**Interior Renovations and  
Repairs to Roadhouse,  
B-3452**

**AMENDMENT NO. 0001**

**INTERIOR RENOVATIONS AND REPAIRS TO ROADHOUSE, BUILDING 3542  
CP0733R1 & WR4122214  
AMENDMENT**

SK-1 (9/19/07)

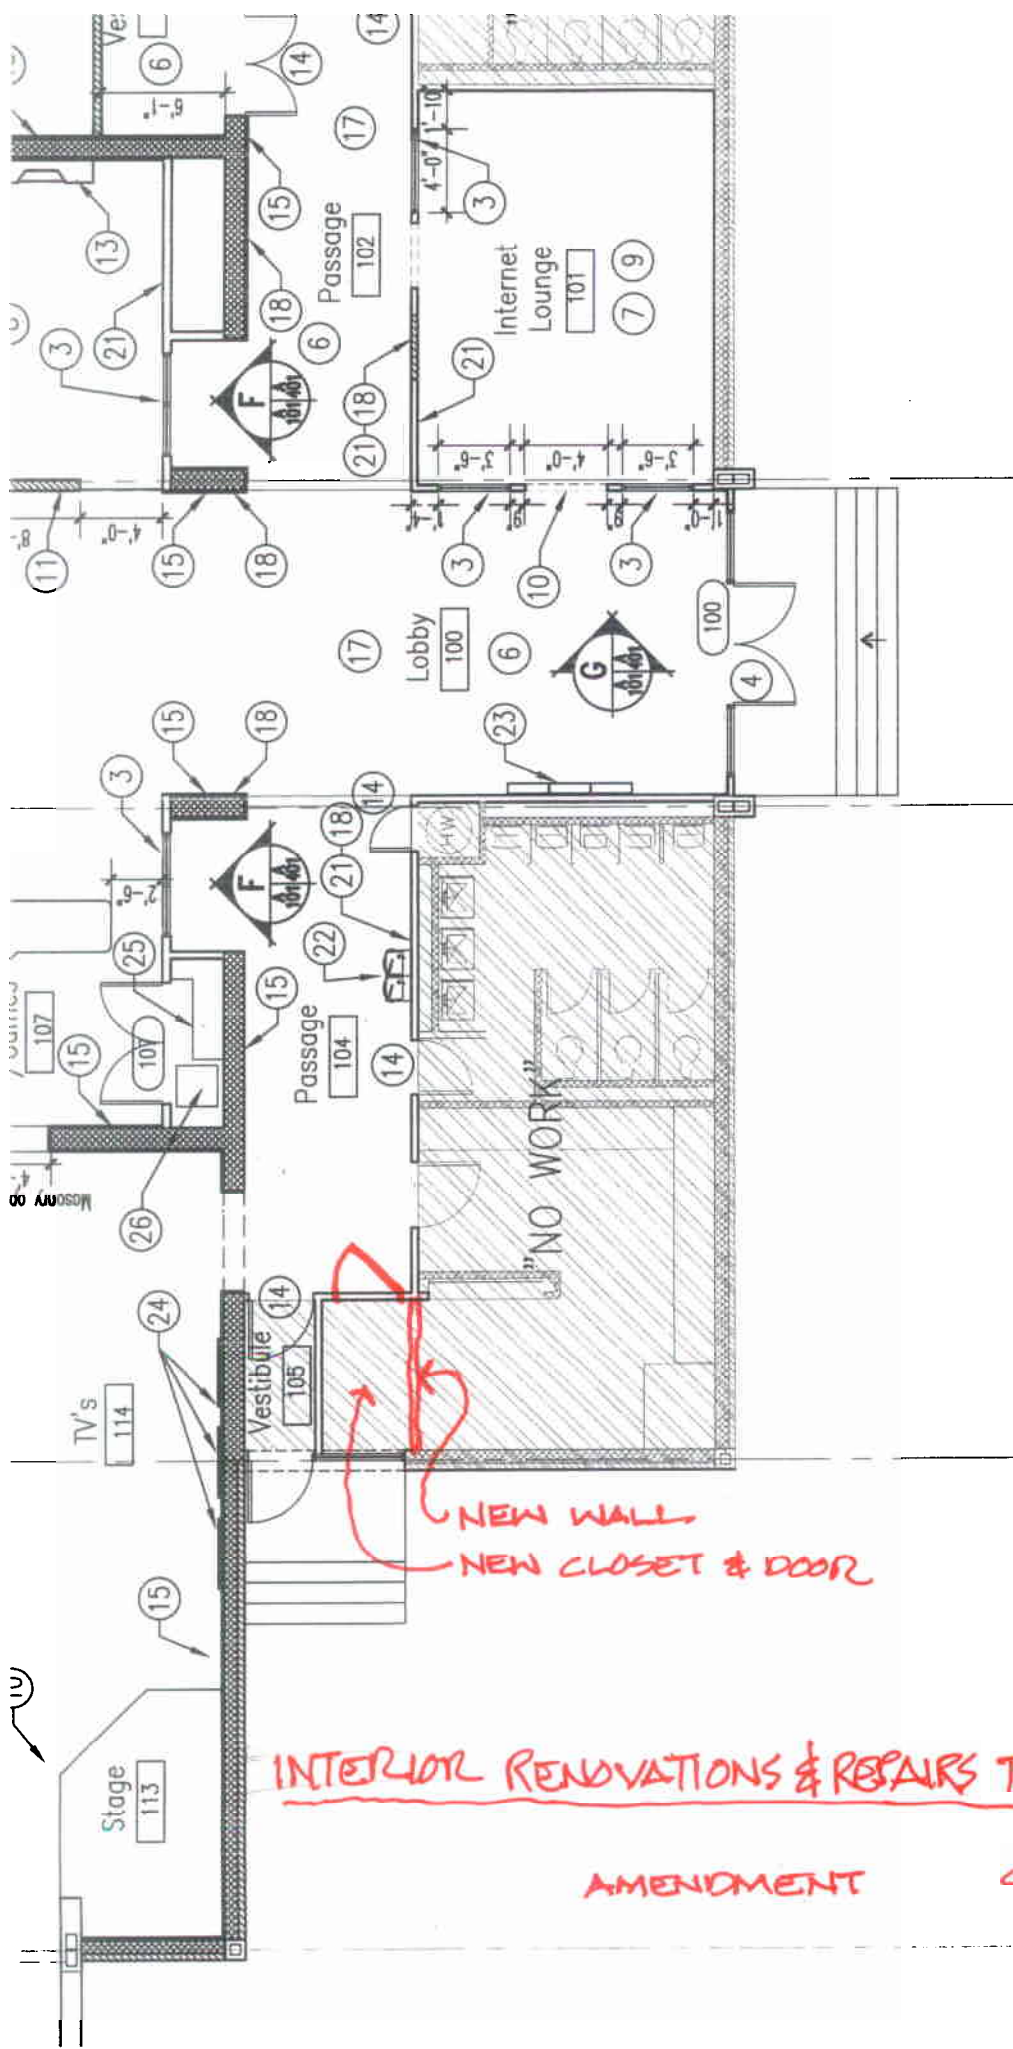
Create New Closet per attached sketch SK-1 (dated 9/19/07), attached to and made apart of this amendment. Wall construction shall be 3 ½” metal studs with ½” gypsum board each side. Extend wall 6” above existing 8’ high acoustical tile & grid ceiling that is to remain. Remove existing carpet that will be in the new closet. Provide the following:

- 3’ wide x 7’ high wood door (type A) in metal frame (type F1) and hardware (1 ½ pair hinges, lockset – BHMA A156.2, series 4000, grade 1) in existing wall
- wall switch in closet to operate existing fluorescent light fixture to remain
- double duplex electrical outlet on dedicated circuit (20A)
- fire rated plywood sheet (4’x7’) unpainted, mounted on wall over the gypsum board
- 2 door mounted transfer grills equal to model SZ-90, type A-1, by L & L Louver, with gray prime coat, approx. size – 12” x 24”
- except for plywood sheet, paint all new construction (prime & 2 coats)
